Office Action Summary

10/540,089

BRANEMARK, PER-INGVAR

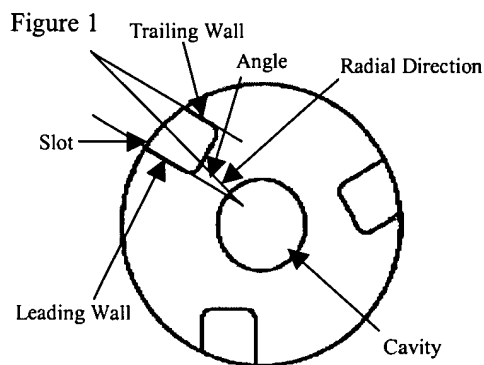
Applicant's arguments filed 11/27/2006 have been fully considered but they are not persuasive. Regarding the applicant's argument that Moore does not disclose slots wherein the radially outermost part of the trailing slot wall defines an angle with the radial direction and slopes obliquely forwardly from within and outwardly in said direction of rotation. The examiner has included Figure 1 above to help further show the reference having the limitations discussed above. As can be seen by the figure, Moore

shows the device having slots wherein the radially outermost part of the trailing slot wall defines an angle with the radial direction and slopes obliquely forward from within and outwardly in the direction of rotation as stated in column 5 lines 1-16.
